Subject: Erratum 2 (05/2007) to

ITU-T Recommendation G.806 (03/2006), *Characteristics of transport equipment – Description methodology and generic functionality*

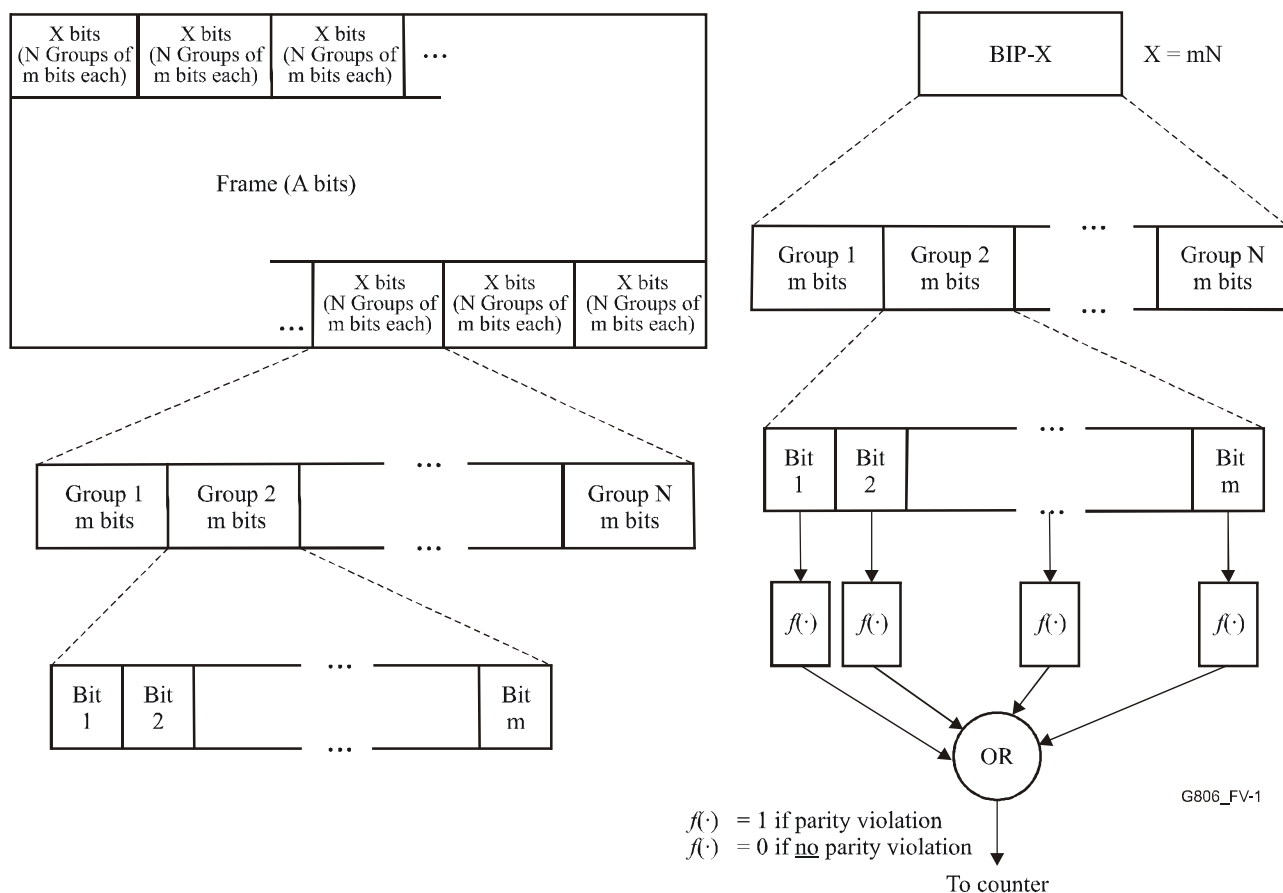
Correct Figure V.1/G.806 as follows changing the condition of $f(\cdot) = 0$ to "if no parity violation":
